Activity Report

Second Participatory Activity

Participatory Workshop on
September 25th 2024

RECONSTRUCTION OF **AVENUE CLAREMONT** AND OF LORRAINE AVENUE

Model 1

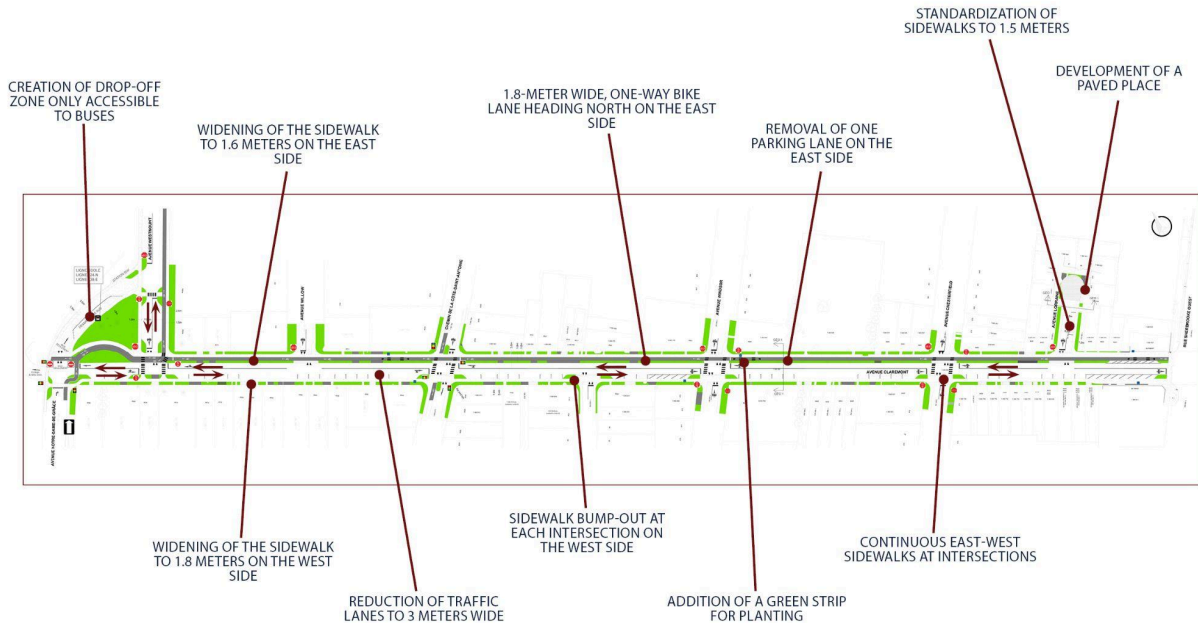
Comments Regarding Model 1

Positions	Explanations
Varied Opinions on the Development of a Small Square on Lorraine Avenue	<p>The reactions from participants are mixed regarding the proposal to develop a small square on Lorraine Avenue. Some view the initiative positively, while others believe it could complicate traffic flow on the avenue and question its relevance. Those in favor of the development emphasise the need to ensure that the square does not cause water accumulation, as the area already faces issues with water management. Additionally, these participants hope that the square will feature permeable pavement and see it as an opportunity to include trees, grass, and other greenery to help reduce rainwater runoff.</p>
NDG-Claremont Island Design Fails to Obtain Consensus	<p>The proposed design for the NDG-Claremont island is divided. A few participants appreciate the design, particularly considering its improvement of pedestrian safety. Many participants specifically like the curved sidewalk included in the proposal.</p> <p>Some participants suggest removing the sidewalk from the island, arguing that this change would preserve two traffic lanes, one for buses and one for cars, while keeping the sidewalk along the Marianopolis property.</p>  <p>On the other hand, several participants would prefer the island to retain its original configuration, which they see as the safest option. Concerns were also raised about the traffic generated by the new traffic directions around the island. Some participants further questioned the decision to restrict access to buses.</p>

Proposed Measures to Slow Down Traffic	<p>Some participants believe it is important to add curb extensions and speed bumps to slow down traffic on Claremont Avenue, near the NDG-Claremont island. They also suggest considering a stop sign instead of traffic lights at the intersection of Notre-Dame-de-Grâce and Claremont Avenues.</p>

<p>Proposals for Access to Marianopolis College</p>	<p>Participants expressed the need to redesign the car entrances to Marianopolis College to encourage access from Westmount Avenue. The goal is to reduce the use of the northern entrance on Claremont. They also requested the creation of a better drop-off zone for students.</p>
<p>Diverging Opinions on the Proposed Bike Lane</p>	<p>Several participants expressed positive views on the northbound bike lane, highlighting that it is safer due to reduced traffic. However, some participants believe it should be designed for two-way traffic.</p> <p>Despite these favorable opinions, some feel that the one-way bike lane on Claremont is inadequate due to a lack of proper infrastructure. They consider it dangerous and unnecessary, noting that the avenue is already narrow and potentially risky for cyclists.</p> <p>Moreover, several participants oppose the presence of a bike lane in this area, citing concerns about traffic and safety. Some noted that parking lot exits are already difficult, and an additional bike lane could further complicate the situation. One participant suggested restricting access to the bike lane during rush hours. Finally, it was proposed to create an additional bike lane on Prince Albert or Victoria to better meet the needs of cyclists.</p>

<p>Diverging Opinions on the pattern of travel in the NDG-Claremont Island Area</p>	<p>Some participants mentioned that they appreciate the street configuration that now limits traffic coming from Notre-Dame-de-Grâce Avenue. However, others believe that drivers on Notre-Dame-de-Grâce Avenue may experience negative effects due to the bottleneck created. They suggest allowing eastbound traffic near the NDG-Claremont Island to help ease congestion.</p>
<p>Concerns About Lane Width for Emergency Vehicles</p>	<p>Some participants expressed concerns about the ability of emergency vehicles to navigate if the streets are narrowed. They also feel that reducing street width could compromise overall safety in the area.</p> <p>One participant suggested widening the streets to improve traffic flow and banning large trucks.</p>

<p>Potential Conflicts Between Buses and Other Road Users</p>	<p>Some participants feel that Claremont Avenue, between Notre-Dame-de-Grâce and Westmount Avenues, is too narrow to accommodate both a bus and a car at the same time.</p>  <p>The bus drop-off zone is viewed positively by some participants as it simplifies transport by eliminating three existing bus stops.</p> <p>However, some participants pointed out that the placement of bus stops creates a conflict with the bike lane in two locations.</p>
<p>Positive Feedback on the Proposed Creation of Green Spaces</p>	<p>The green spaces proposed in this plan were well received by participants. They emphasised the importance of preserving vegetation, especially the trees throughout the area, with particular focus on protecting the linden tree in the NDG-Claremont island and the mature trees lining both avenues.</p> <p>The vegetated strip on Claremont Avenue is widely appreciated by participants, as it contributes to a pleasant, green atmosphere in the area while enhancing the safety of active transportation and improving rainwater management.</p>

<p>Concerns About Snow Removal</p>	<p>Some participants expressed concerns regarding snow removal for the new pedestrian and cycling infrastructure, particularly about where the snow will accumulate. They stressed the importance of ensuring that the bike lane and the green strip are cleared of snow to maintain accessibility for people with reduced mobility.</p>
<p>Secondary Opinions</p> <ul style="list-style-type: none"> • Participants also mentioned the synchronization of traffic lights as an area for improvement.

Model 2

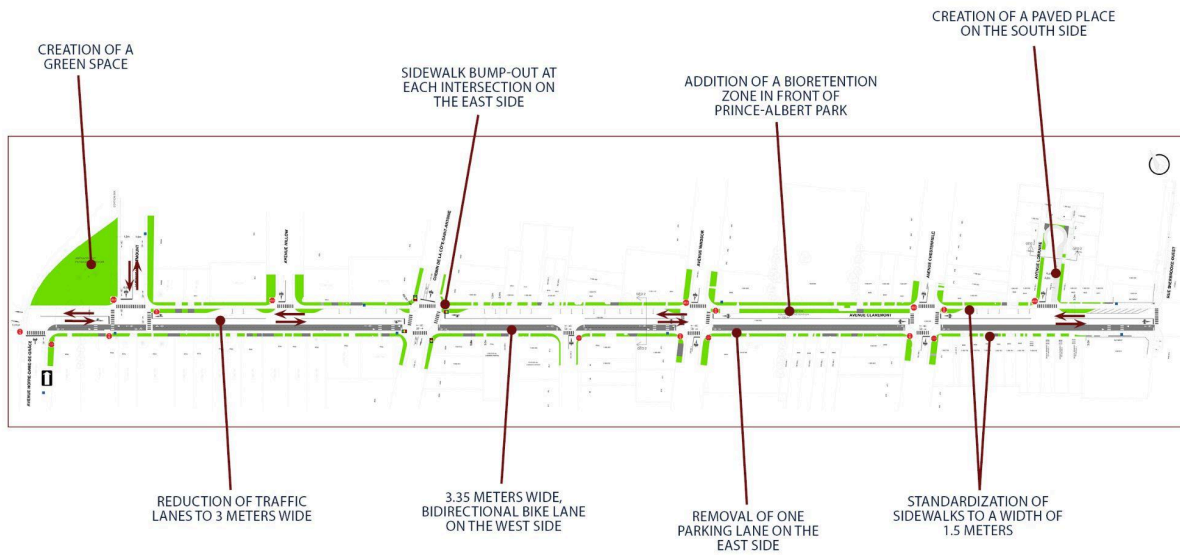
Comments Regarding Model 2

Positions	Explanations
<p>Preference for the Proposed Square in Model 1 on Lorraine Avenue</p>	<p>Some participants suggested reintroducing the square from model 1 located on Lorraine Avenue. The presence of a square is seen as an effective way to slow down vehicles and reduce traffic flow.</p>
<p>Questions Raised Regarding the Closure of the Ramp</p>	<p>Some people appreciate that the access ramp to the NDG-Claremont island is closed. However, although this measure aims to discourage automobile transit in the area, several individuals question its effectiveness and worry that this intervention will increase traffic in the NDG-Claremont island area. They note that this area experiences significant automobile flow during peak hours, and that closing the ramp complicates eastward travel.</p> <p>Moreover, some individuals suggest closing Claremont Avenue in front of the NDG-Claremont island and extending Notre-Dame-de-Grâce Avenue into the ramp to connect it to Westmount Avenue.</p>

<p>Requests for Specific Improvements in the NDG-Claremont Island</p>	<p>Participants want to see an increase in the tree canopy in the NDG-Claremont island and hope the proposed development will enhance water management. They also want special attention given to the design to encourage its use by residents and the student population.</p>
<p>Proposal to Relocate Marianopolis College's Entrance</p>	<p>Several participants suggested moving the entrance to Marianopolis College, currently located at the end of Claremont Avenue. The goal of this change would be to eliminate the northbound lane between Westmount and Notre-Dame-de-Grâce Avenues. They propose reconfiguring the east entrance of Marianopolis to help reduce congestion at the intersection adjacent to the island.</p>
<p>Concerns About Pedestrian Safety in the Northern Area and at Intersections Without Traffic Lights</p>	<p>The lack of pedestrian lights and crosswalks on Notre-Dame-de-Grâce Avenue near the island raises concerns about the safety of active transportation in this area.</p> <p>In addition, east-west pedestrian crossings at intersections without traffic lights—such as Chesterfield, Windsor, and Westmount Avenues—are considered dangerous by some participants. These routes require crossing a two-way bike lane, and cyclists do not always comply with stop signs. To address this issue, some participants suggest replacing stop signs with traffic lights to improve safety.</p>

<p>Diverging Opinions on the Proposed Two-Way Bike Lanes and Suggestions to Improve the Bike Network</p>	<p>Some participants support the presence of bike lanes along the corridor but question the need for two lanes instead of one. Others prefer a two-way lane to facilitate better traffic flow for cyclists, taking advantage of the wide layout of Claremont Avenue.</p> <p>However, several participants pointed out that having a two-way bike lane on one side of the street creates conflicts with bus stops, parking, and multiple driveways. Additionally, this configuration raises concerns about managing traffic from private parking lots, such as the one at 500 Claremont Avenue, which has parking for multiple vehicles opening onto the bike lane.</p> <p>One participant mentioned the presence of a southbound bike lane on Lansdowne Avenue and questioned the necessity of a two-way lane. They also noted that the transition between the bike lane on Claremont Avenue and the bike path on Westmount Avenue is not ideal and poses a danger to users.</p> <p>It was also proposed to move the bike lane on Notre-Dame-de-Grâce Avenue to the north side of the street, adjacent to the Marianopolis College grounds, to create a continuous path toward Westmount Avenue.</p>

<p>Concerns About Potential Conflicts Between Cyclists and Buses</p>	<p>The layout of bus stops raises concerns, as cars overtaking stationary buses at the stops pose dangers to other road users. Participants believe it is necessary to rethink the design to include specific spaces for buses to stop without obstructing the visibility of other road users.</p> <p>Additionally, the location and design of bus stops on the west side of Claremont Avenue are contested, as no specific measures seem to address potential conflicts with cyclists. Participants are particularly concerned about the design of the bus stops on Sherbrooke Street, where some vehicles park on the street, making bus maneuvers difficult. Finally, some participants prefer bus stops without shelters.</p>
<p>Concerns About the Removal of Parking Spaces</p>	<p>The removal of several parking spaces has raised concerns among participants, who fear that the parking supply in this plan may not be sufficient to meet demand. The removal of parking spaces in the southern part of Claremont Avenue has cast doubt on the viability of the proposed layout. This area experiences high demand from local residents as well as visitors to businesses on Sherbrooke Street.</p> <p>Additionally, some participants are displeased with the removal of parking spaces between Westmount Avenue and Willow Avenue in favour of vegetated curb extensions.</p>

<p>Diverging Opinions on the Proposed Vegetated Curb</p>	<p>Some participants appreciate the proposed vegetated curb extension between Lorraine Avenue and Sherbrooke Street. However, others are not in favour, arguing that there is not</p>

Extension on the South End of Claremont Avenue	enough space for cars to stop in front of buildings that do not have private parking.
Positive Reception Regarding the Bioretention Infrastructure	The addition of a vegetated bioretention area was well received by many participants.
Request for More Green Spaces	Participants noted the reduced amount of green space compared to model 1 and expressed their desire to increase the vegetated areas in the sector.
Secondary Opinions	<ul style="list-style-type: none"> The absence of bike boxes allowing cyclists to stop safely before turning at intersections was noted, particularly at the intersection of Claremont Avenue and Westmount Avenue.

Model 3

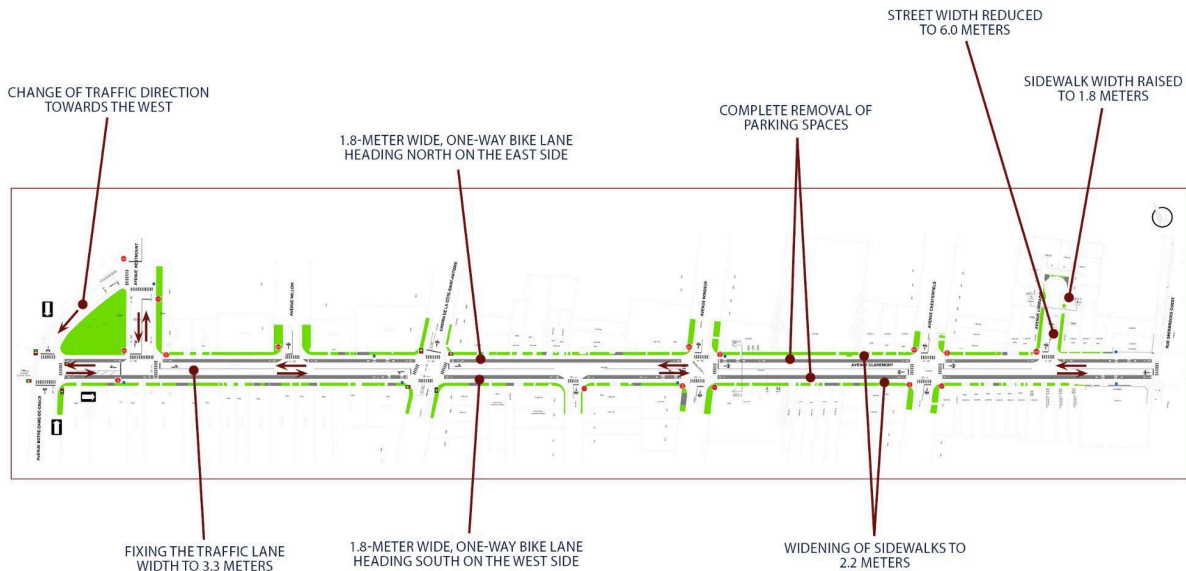
Comments Regarding Model 3

Positions	Explanations
Preference for the Proposed Square in Model 1 on Lorraine	Some participants suggest reintroducing the square from model 1 located on Lorraine Avenue. They prefer the first model because it discourages traffic and promotes better management of rainwater.
Negative Opinions on the Proposed Access for Marianopolis College	Some participants suggest prioritising access to Marianopolis College via Westmount Avenue to improve traffic flow on Claremont Avenue, rather than favouring access to the soccer fields located to the west of Marianopolis.
Disputed Layout of Bike Lanes	<p>The proposed bidirectional bike lanes in this model do not have unanimous support among participants.</p> <p>For some, these lanes are seen as a good idea, but others are concerned that vehicles may park in them due to the lack of designated parking spaces. Additionally, some participants oppose the idea of bidirectional bike lanes on Claremont, especially to the south, deeming them too dangerous.</p> <p>Others prefer the bidirectional bike lanes of model 2, located on the west side, and believe it is better to have lanes on only one side, ideally on the west side, as this would avoid conflicts between cyclists and people going to the park.</p> <p>Finally, participants express dissatisfaction with the lack of protection for the bike lanes.</p>

<p>Concerns Raised Regarding the Proposed Traffic Direction in the NDG-Claremont Island Area</p>	<p>Participants wish for the reopening of the ramp heading east from Notre-Dame-de-Grâce Avenue to Westmount Avenue, considering this intervention necessary to improve traffic flow. Many participants want to maintain two lanes north of Claremont Avenue and call for two turning lanes on Notre-Dame-de-Grâce Avenue. They highlight that the majority of traffic flows from Notre-Dame-de-Grâce Avenue to Westmount Avenue, making the proposed reverse traffic direction illogical.</p> <p>Furthermore, concerns are expressed about the potential danger posed by the left turn from the diagonal of Westmount Avenue onto Notre-Dame-de-Grâce Avenue.</p>
<p>Anticipated Conflicts Between Cyclists and Buses</p>	<p>Participants believe it is dangerous for pedestrians to have to cross the bike lane to access the bus stops. Thus, one person suggests relocating the bus stops on Notre-Dame-de-Grâce and Westmount Avenues.</p>

<p>Disapproval of the Complete Removal of Parking Spaces</p>	<p>The total removal of parking is deemed excessive by several participants, who prefer a reduction while maintaining a necessary supply. In fact, many residents do not have private parking. Questions arise regarding the management of deliveries in the absence of parking.</p>
<p>Concerns About the Lack of Proposed Green Spaces</p>	<p>The lack of green space in this model is a concern raised by several participants.</p>
<p>Inadequate Water Management</p>	<p>Questions have been raised regarding the management of runoff water in this model. The absence of additional green space is viewed negatively by some participants.</p>
